Agar Grove Phase 1c

Air Source Heat Pump Design - Comparison

Phase 1c - Approved and Minor Material Amendment

Block I - East Elevation

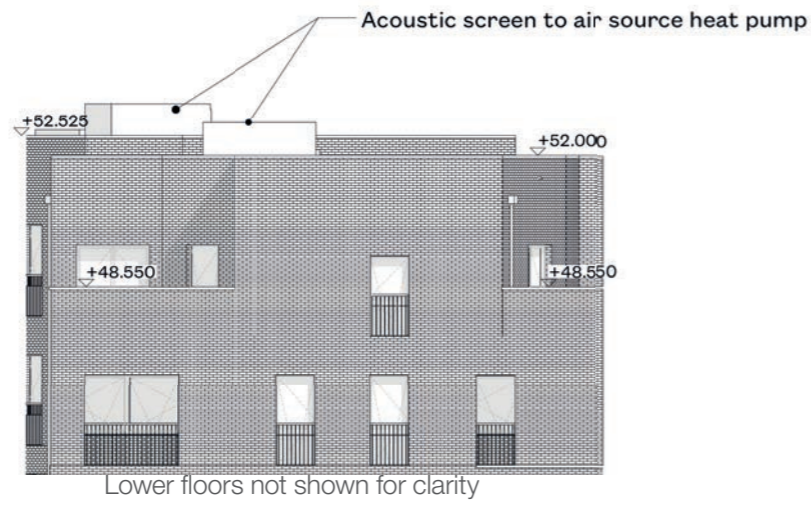
ASHPs and enclosure - Approved October 2020
East Elevation

ASHPs and enclosure - Proposed Minor Material Amendment February 2023
East Elevation

Block I - North/South Elevations

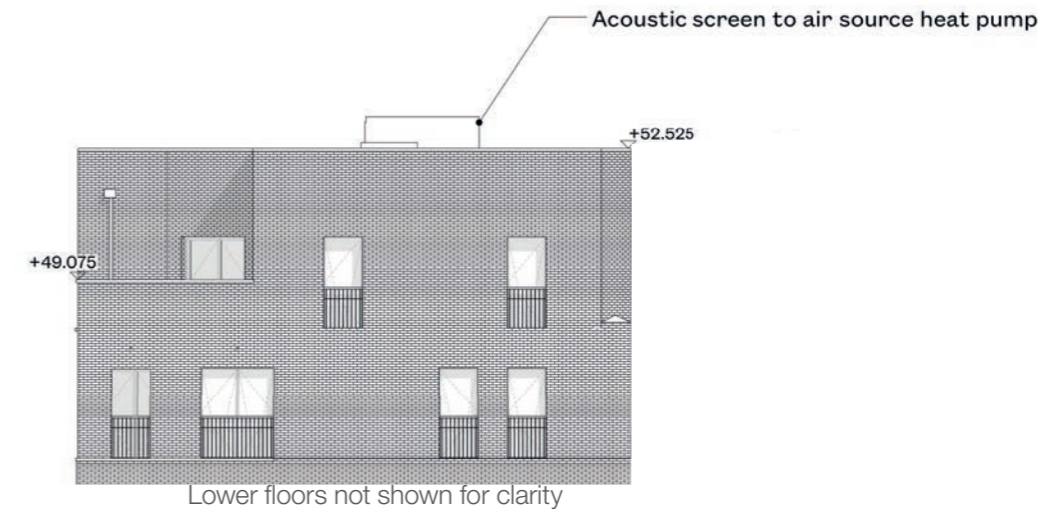
ASHPs and enclosure - Approved October 2020
South Elevation

ASHPs and enclosure - Approved October 2020
North Elevation

ASHPs and enclosure - Proposed Minor Material Amendment February 2023
South Elevation

ASHPs and enclosure - Proposed Minor Material Amendment February 2023
South Elevation

Block I - West Elevation

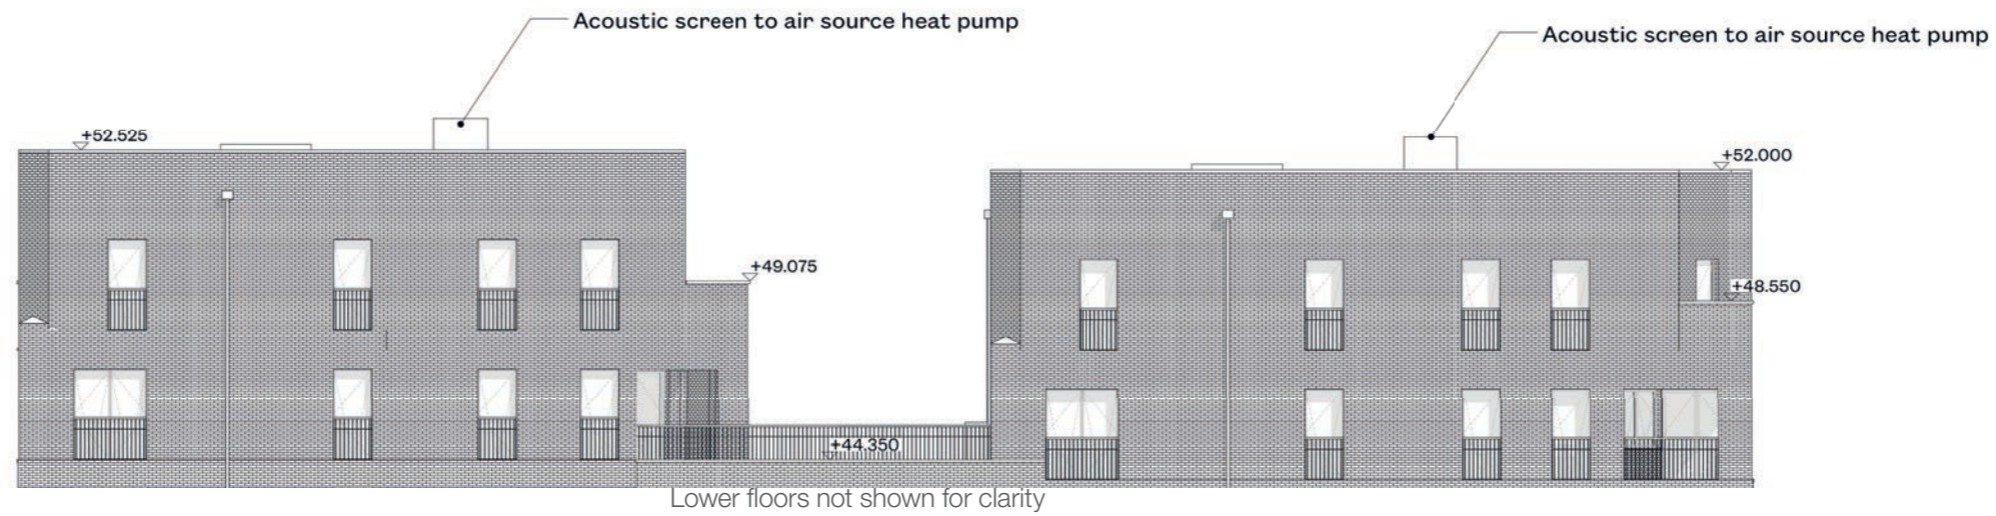
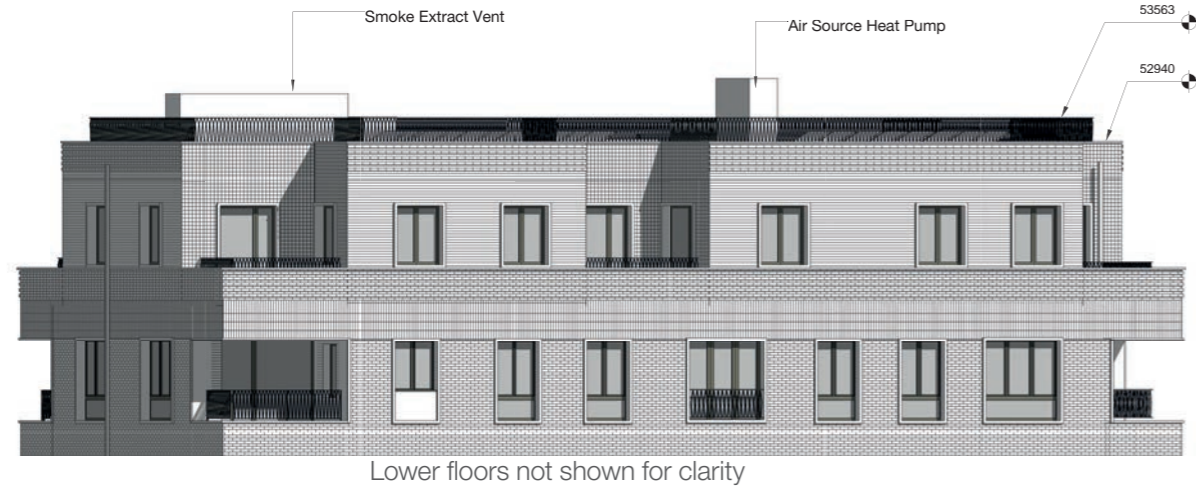
ASHPs and enclosure - Approved October 2020
West Elevation

ASHPs and enclosure - Proposed Minor Material Amendment February 2023
West Elevation

Block JKL - East/North Elevations

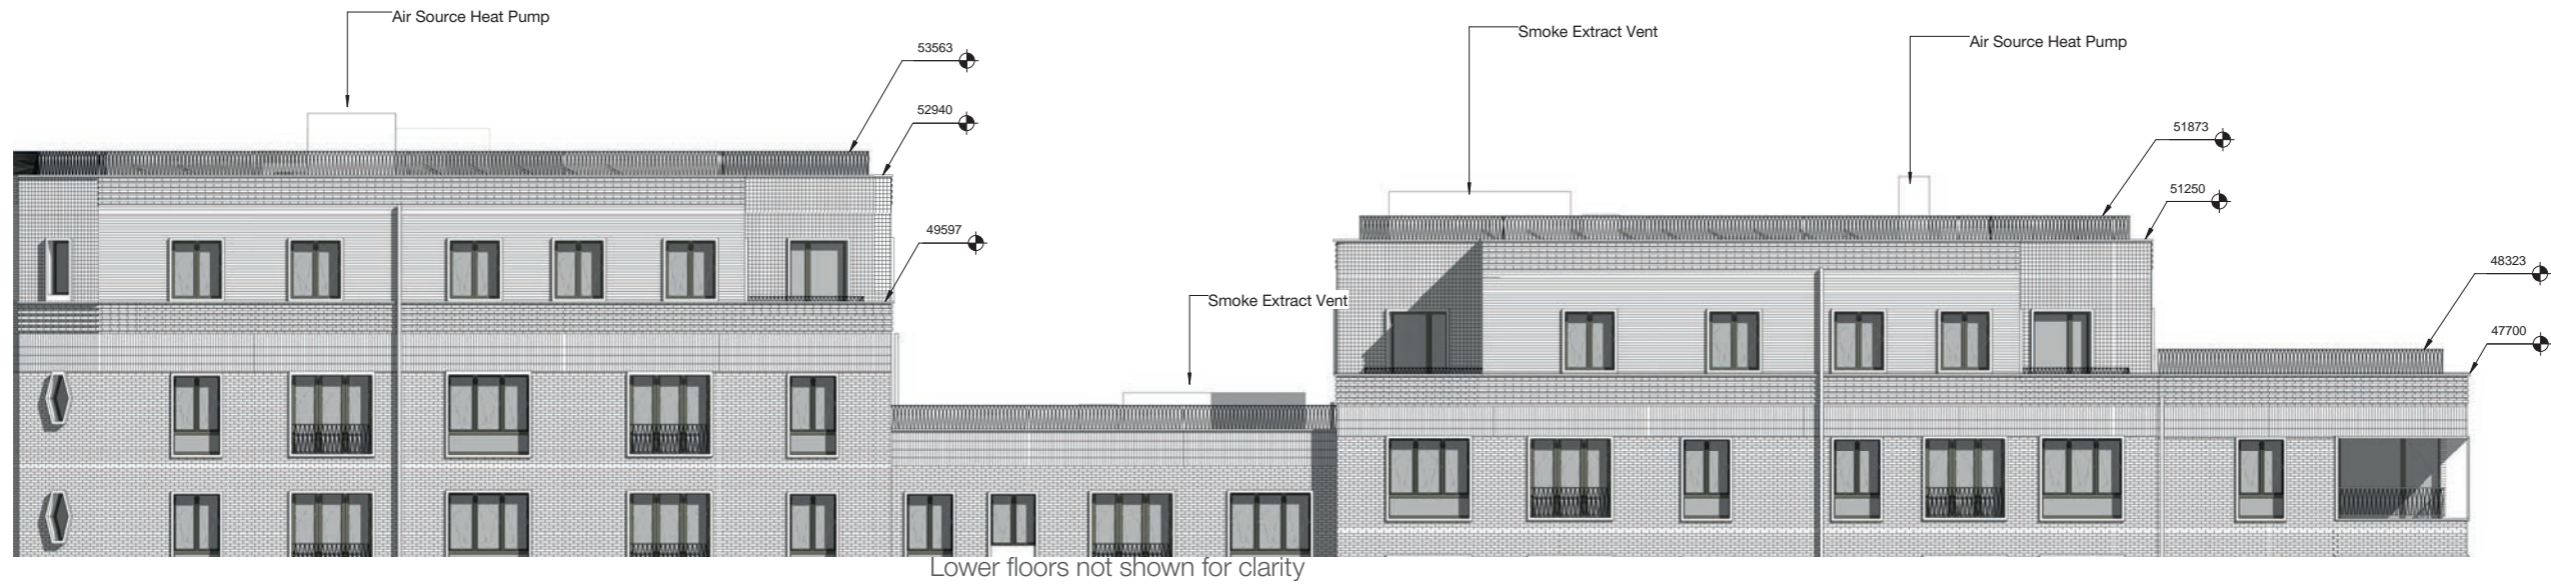
ASHPs and enclosure - Approved October 2020
East Elevation

ASHPs and enclosure - Approved October 2020
North Elevation

ASHPs and enclosure - Proposed Minor Material Amendment February 2023
East Elevation

ASHPs and enclosure - Proposed Minor Material Amendment February 2023
North Elevation
